## HISTORIC AND DESIGN REVIEW COMMISSION

**HDRC CASE NO:** 2019-699  
**ADDRESS:**  
911 N PINE ST  
913 N PINE ST  
915 N PINE ST  
917 N PINE ST  
**LEGAL DESCRIPTION:**  
NCB 531 (PINE AT HAYS {IDZ}), BLOCK 13 LOT 25  
NCB 531 (PINE AT HAYS {IDZ}), BLOCK 13 LOT 26  
NCB 531 (PINE AT HAYS {IDZ}), BLOCK 13 LOT 27  
NCB 531 (PINE AT HAYS {IDZ}), BLOCK 13 LOT 28  
**ZONING:** IDZ, H  
**CITY COUNCIL DIST.:** 2  
**DISTRICT:** Dignowity Hill Historic District  
**APPLICANT:** Ricardo Turrubiates/Terramark  
**OWNER:** K/T TX Holdings & T/A Apartments Inc  
**TYPE OF WORK:** Construction of a mixed-use development with multiple structures  
**APPLICATION RECEIVED:** June 26, 2020  
**60-DAY REVIEW:** Not applicable due to City Council Emergency Orders  
**CASE MANAGER:** Edward Hall  
**REQUEST:**

HDRC Case #: 2019-699

# Pine Street Studios

**REAR &  
LEFT ELEV.**

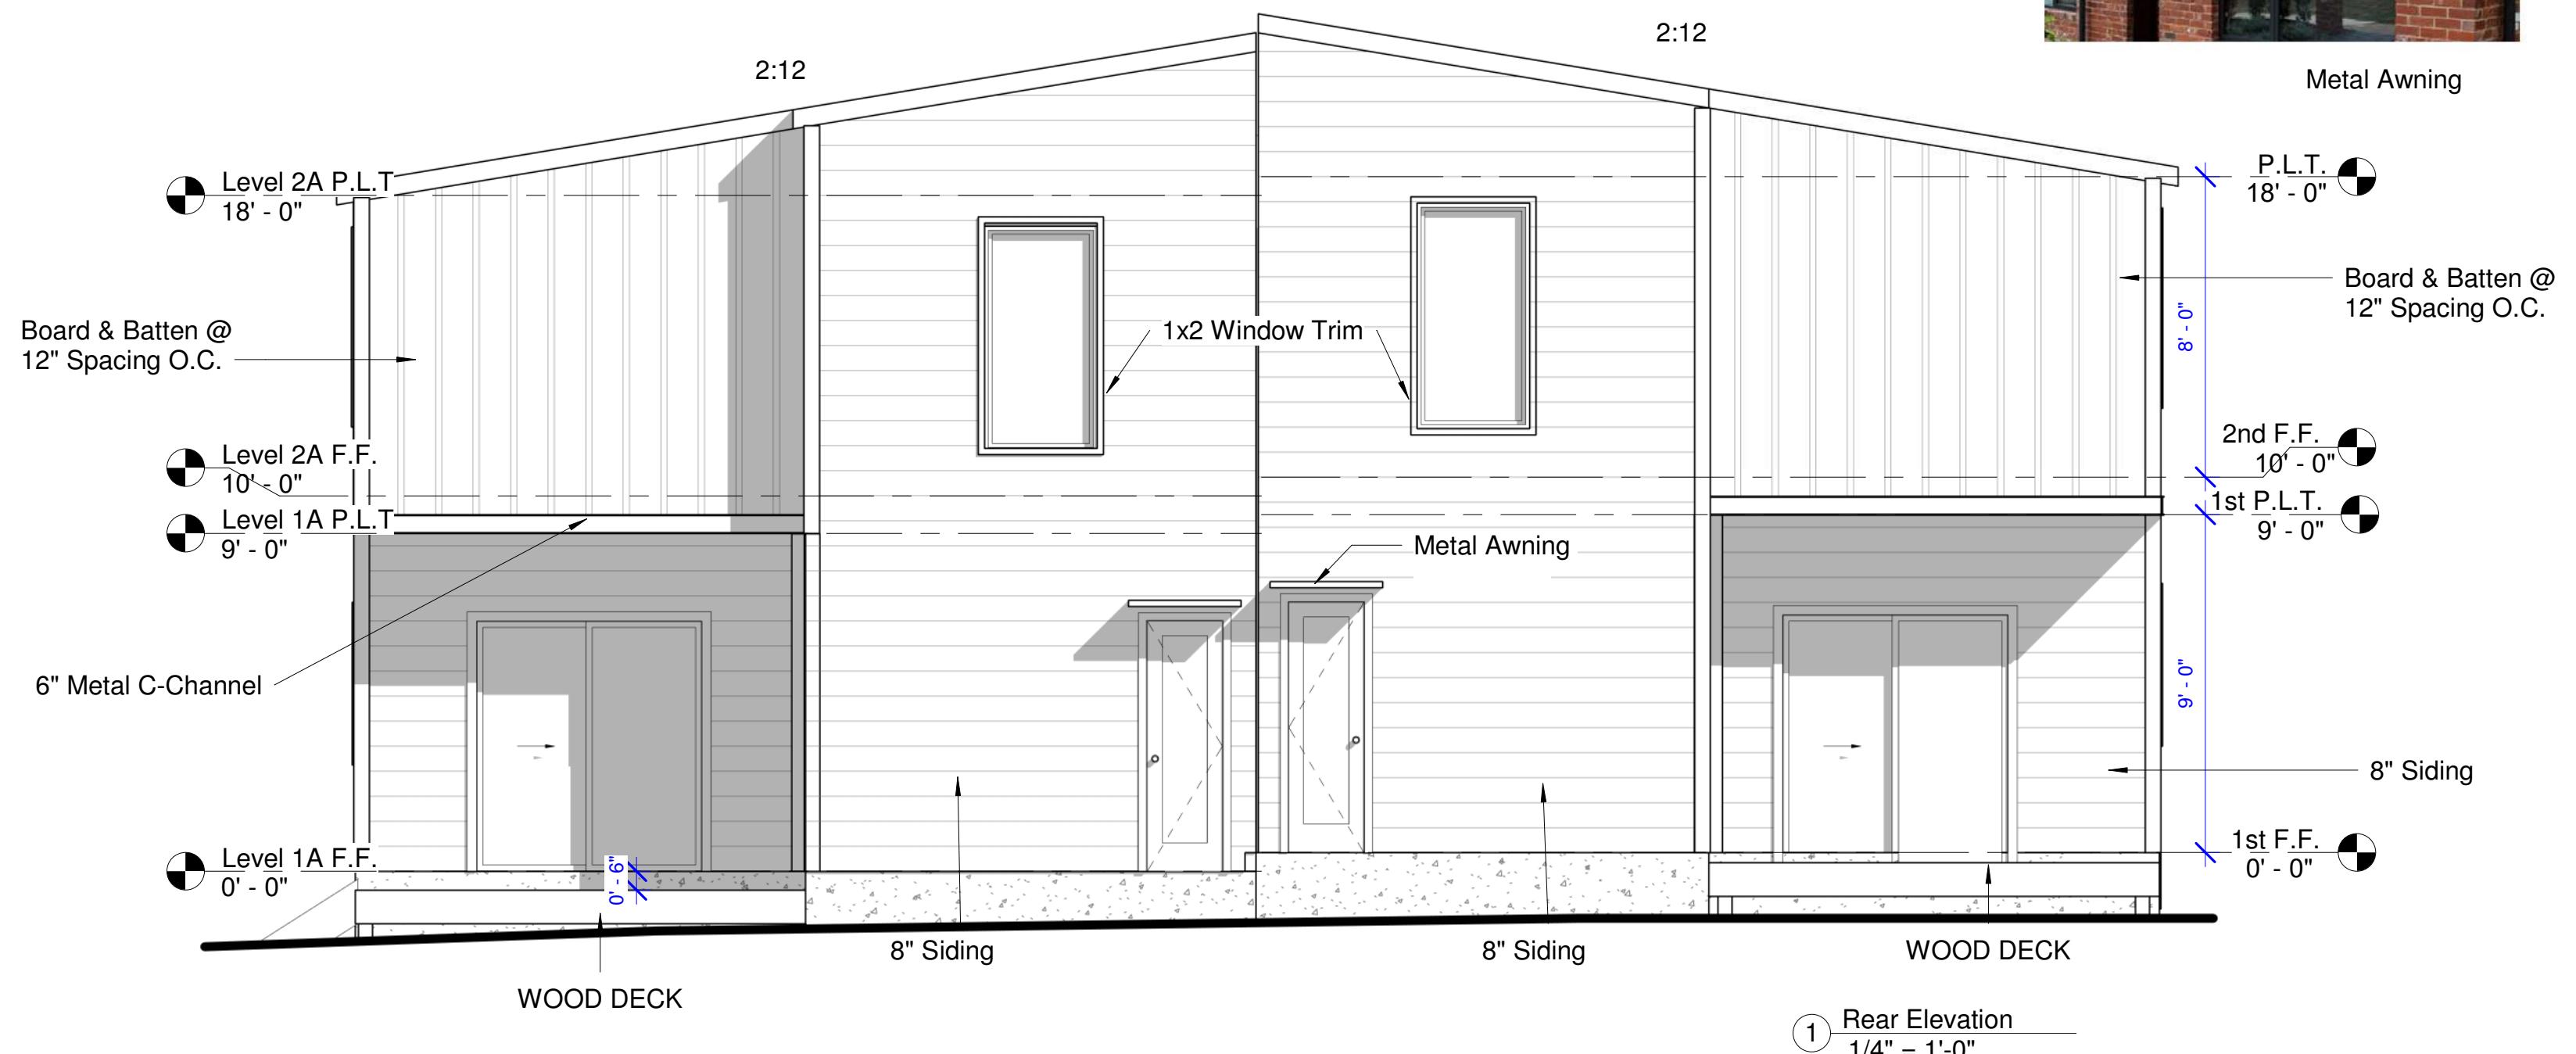
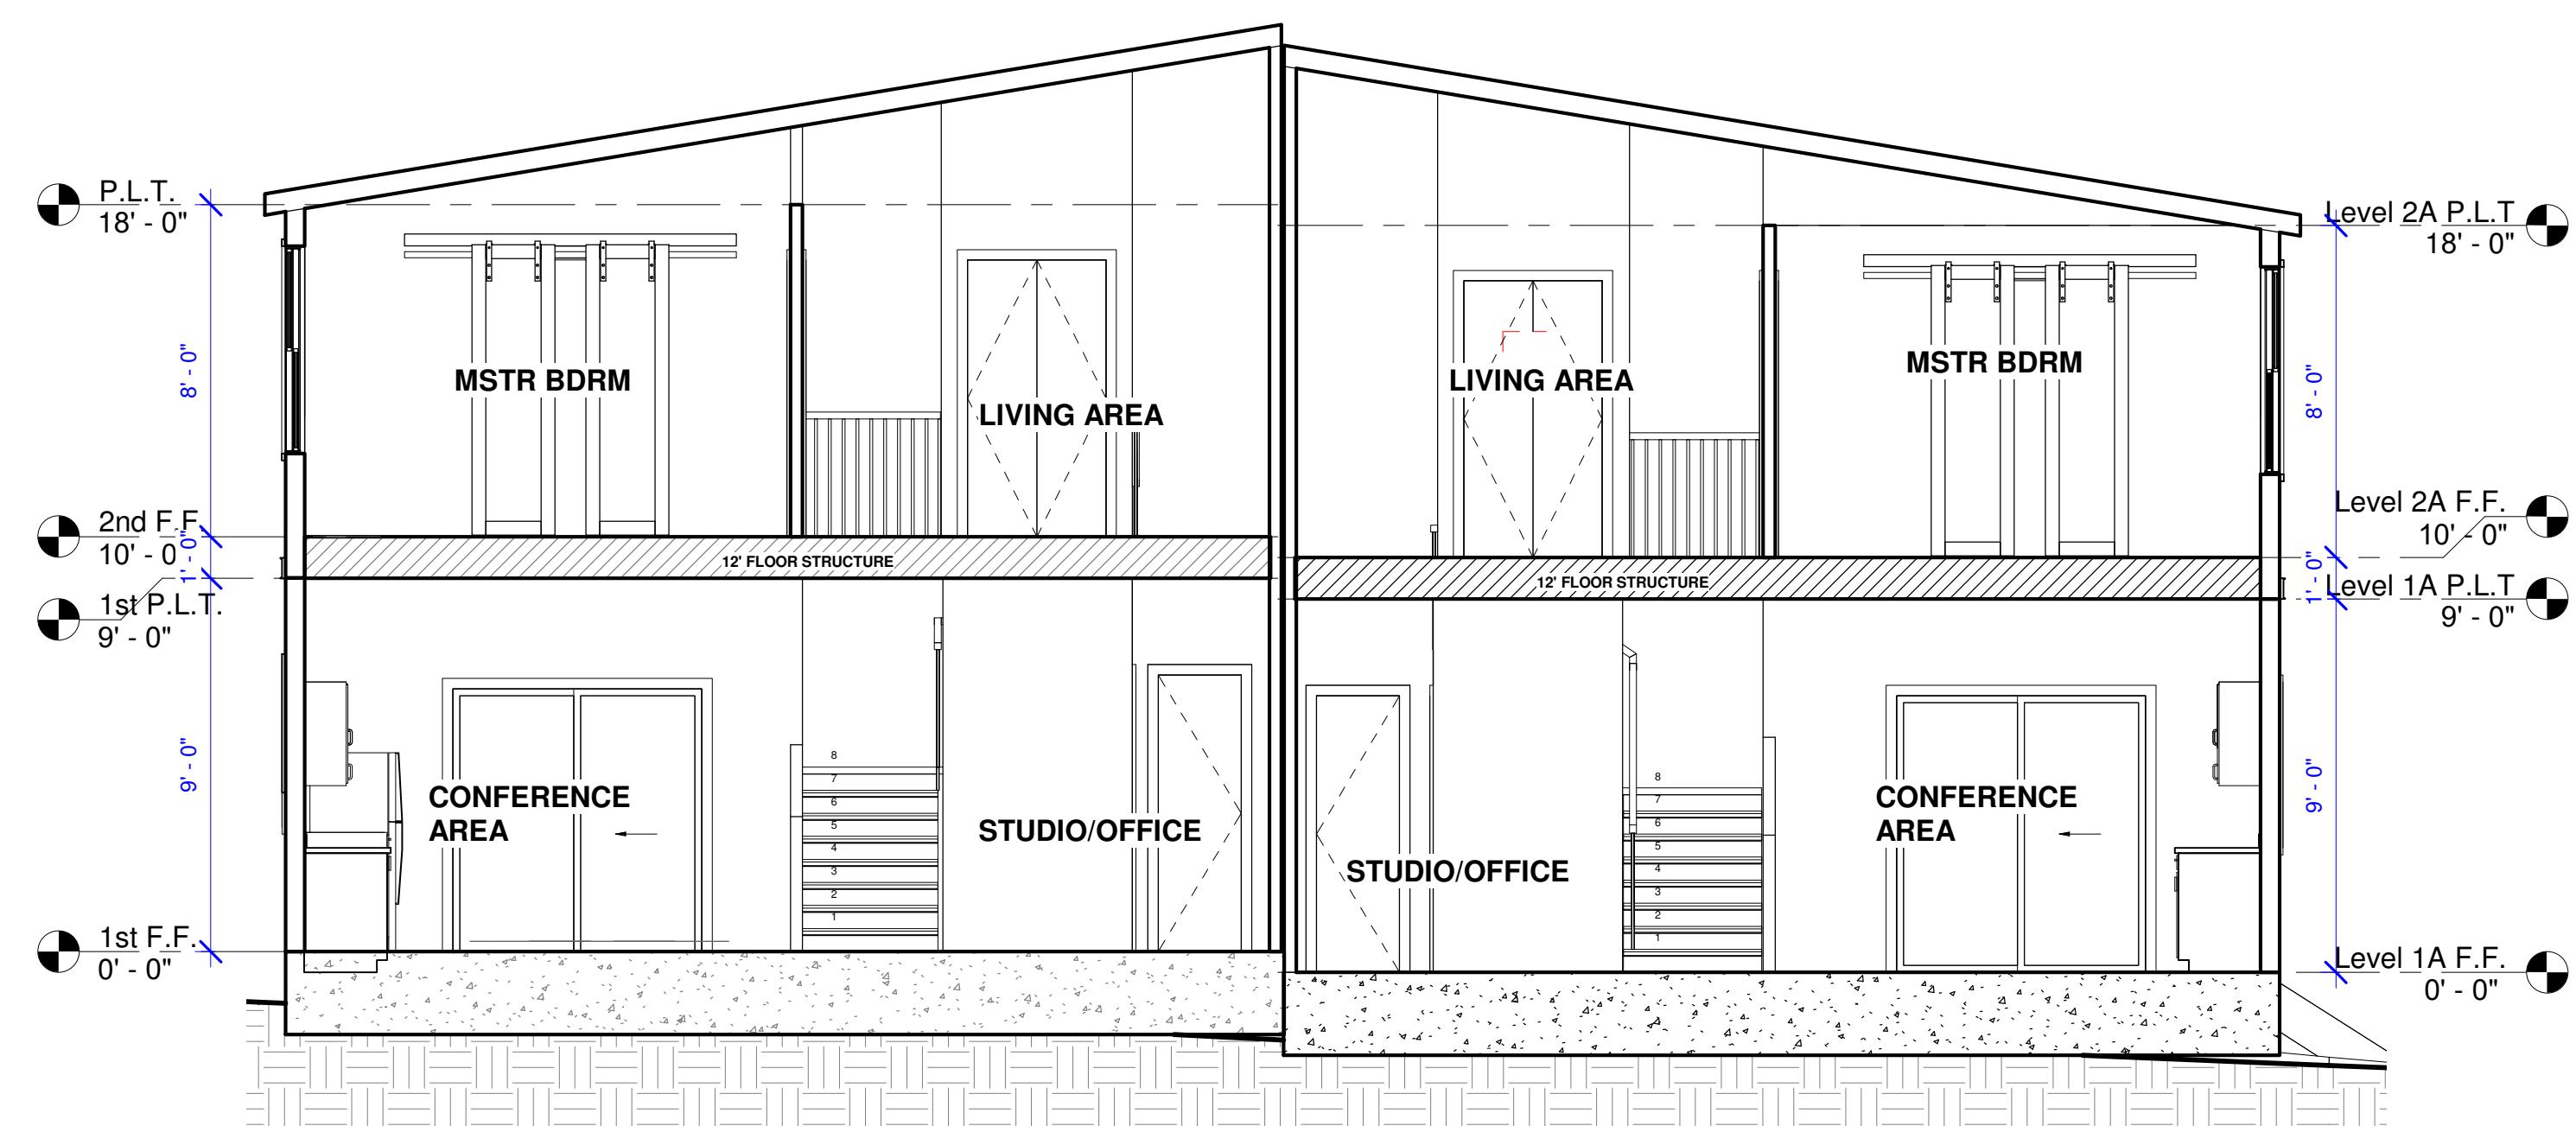
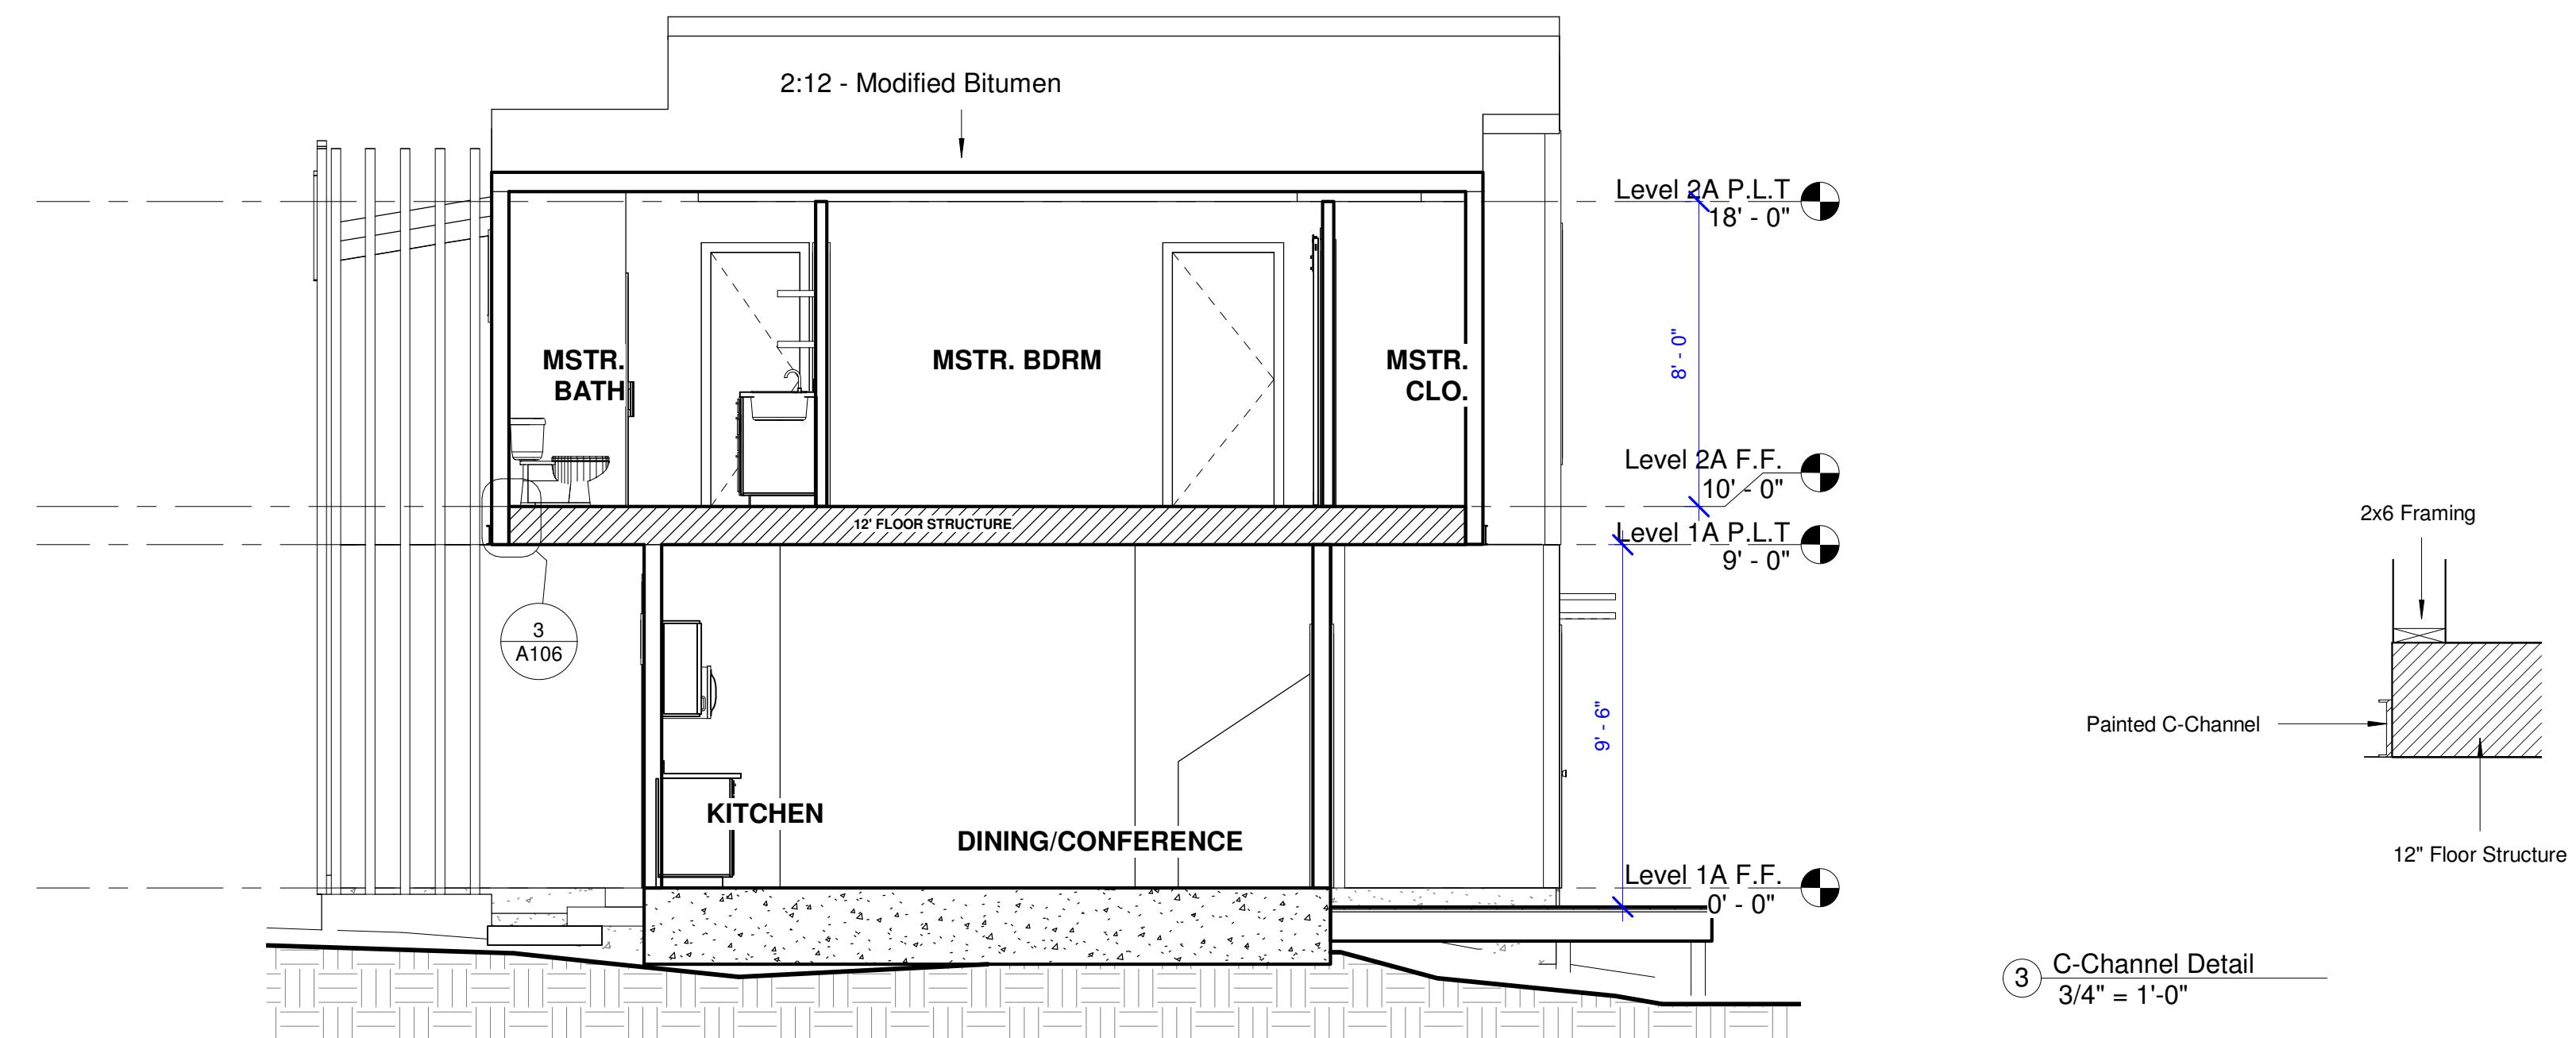
JF: There are blank walls and the north elevation that should be separated with design elements; they do not read as residential. One over one windows should be used. Horizontal windows do not speak as being residential and are not found within the neighborhood historically.

JF: The north façade should be softened with more traditional elements (windows). East and West facades should align with each other vertically (as found historically within the district).

- iv. That the applicant implement window and door openings that are consistent with the Guidelines those found historically within the district as noted in finding l.

## WINDOW DETAILS

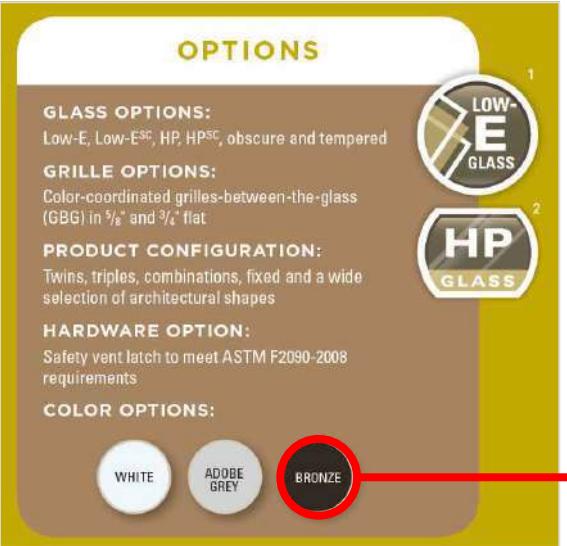
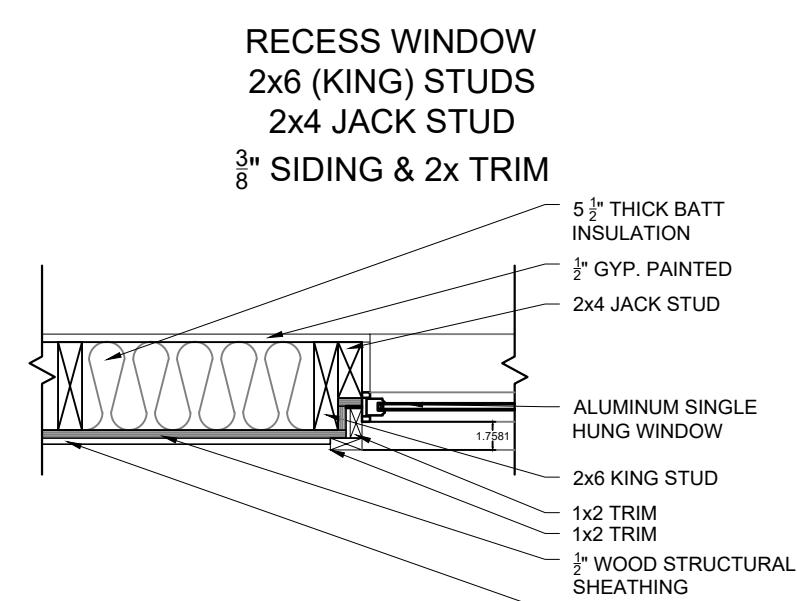
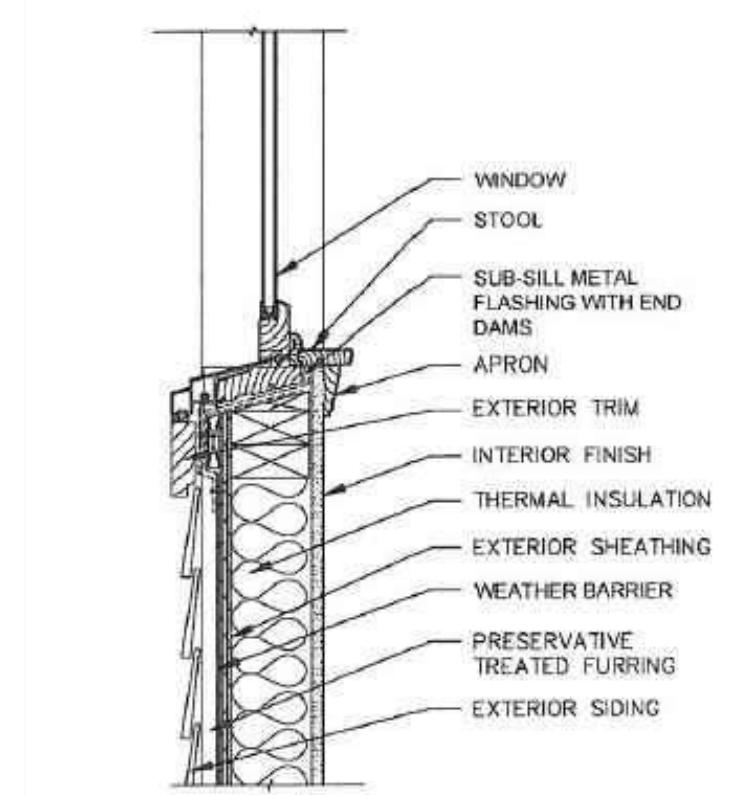
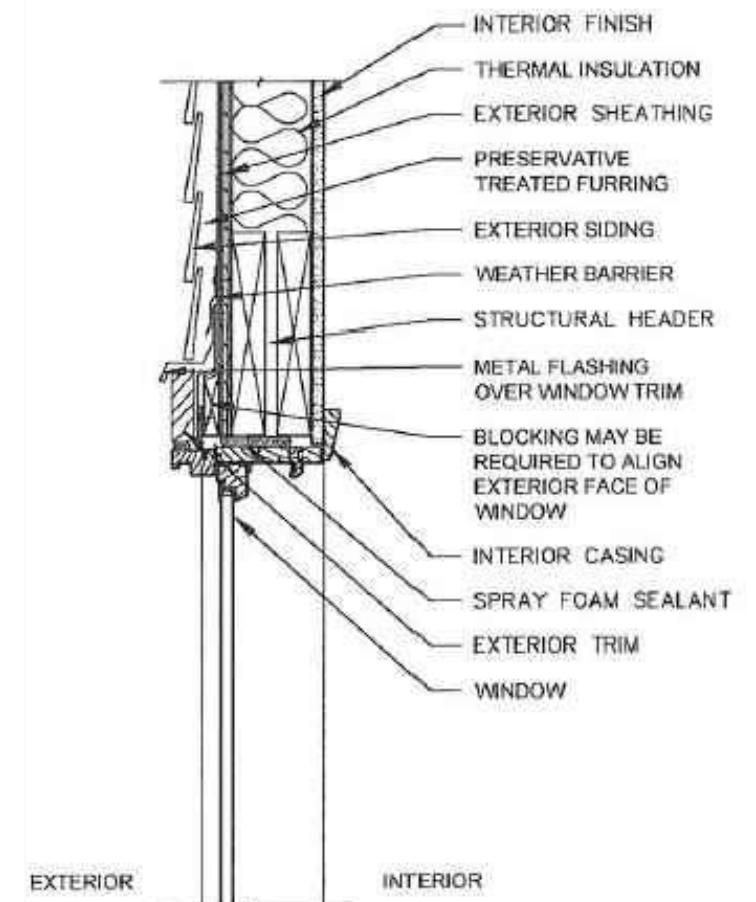
- n. WINDOW MATERIALS – The applicant has proposed to install aluminum windows. Staff finds that the proposed window should be consistent with staff's specifications for windows in new construction, which are noted in the applicable citations.

- vi. That the applicant install windows that are consistent with staff's standard specifications for windows in new construction, as noted in finding n.
